Amendments to the 2018 International Residential Code

DEPARTMENT OF BUILDING SAFETY CITY OF COLLEYVILLE BUILDING INSPECTIONS DEPARTMENT

****Figure R602.6.1; delete the figure and insert the following figure:**

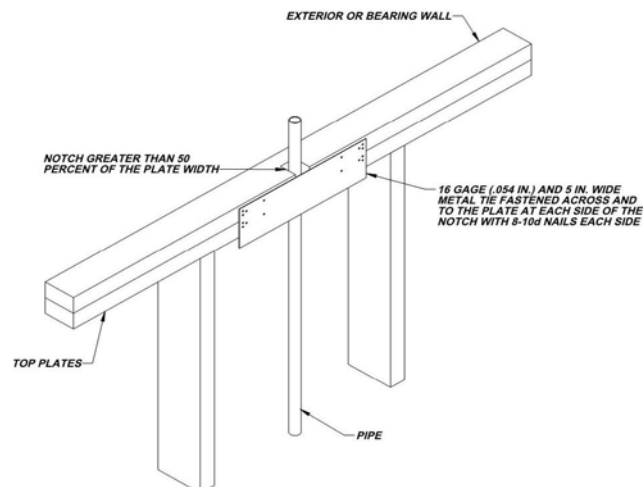
R602.6.1 Drilling and notching of top plate. When piping or ductwork is placed in or partly in an exterior wall or interior load-bearing wall, necessitating cutting, drilling or notching of the top plate by more than 50 percent of its width, a galvanized metal tie not less than 0.054 inch thick (1.37 mm) (16 Ga) and ~~4 ½ inches (38 mm)~~ 5 inches (127 mm) wide shall be fastened across and to the plate at each side of the opening with not less than eight 10d (0.148 inch diameter) having a minimum length of 1 ½ inches (38 mm) at each side or equivalent. Fasteners will be offset to prevent splitting of the top plate material. The metal tie must extend a minimum of 6 inches past the opening. See figure R602.6.1. {remainder unchanged}

(Amendment to 2015 IRC carried forward to 2018 IRC also provides additional assurance of maintaining the integrity of the framing by spreading the nailing pattern.)
